# Access Compliance Report

## Public Rights-of-Way

Intersection ID: 52551	Main Street: KRISTENS_MARE_DR	Cross Street: ARDREY_WOODS_DR	Location: S
ADA ID: B3C736CA8C40	Ramp Type: PerpDiag	Initial Pass/Fail: Fail	Overall Compliance: No
Severity Score: 1.25			
Codes/Mitigation Info/Possible Solution		Field Measurements/Component Compliance

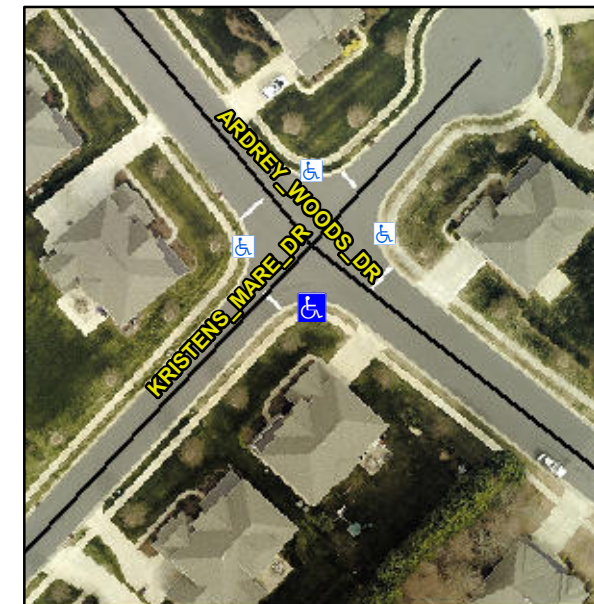
**Remove & Replace Curb Ramp With Two New Directional Ramps or Equivalent.**

**Not Found, R304.5.3**

Compliance	Description	Data	Compliance	Description	Data
N/A	Ramp Length (in)	48.0	Yes	Ramp Slope (%)	5.7
Yes	Ramp Width (in)	48.0	No	Ramp XSlope (%)	3.2
N/A	Flare Type LT	N/A	N/A	Flare Type RT	N/A
N/A	Flare Slope LT (%)	N/A	N/A	Flare Slope RT (%)	N/A
N/A	Flare Traversable LT?	N/A	N/A	Flare Traversable RT?	N/A
N/A	Landing Length (in)	N/A	N/A	DWS Provided?	N/A
N/A	Landing Width (in)	N/A	N/A	DWS Contrast?	N/A
N/A	Landing Slope (%)	N/A	N/A	DWS Length (in)	N/A
N/A	Landing X Slope (%)	N/A	N/A	DWS Full Width?	N/A
N/A	Landing Curb? (Y/N)	N/A	N/A	DWS Offset (in)	N/A
N/A	Shared Landing?	N/A			
N/A	Gutter Ponding?	N/A	N/A	Gutter Slope (%)	N/A
N/A	Gutter Lip Ht (in)	N/A	N/A	Gutter X Slope (%)	N/A
N/A	Painted X Walk1?	No	N/A	Painted X Walk2?	No
	X Walk 1 Direction	To NE		X Walk 2 Direction	To NW
N/A	X Walk 1 Width (in)	N/A	N/A	X Walk 2 Width (in)	N/A
	X Walk 1 Slope (%)	2.1		X Walk 2 Slope (%)	0.1
	X Walk 1 X Slope (%)	1.3		X Walk 2 X Slope (%)	1.2
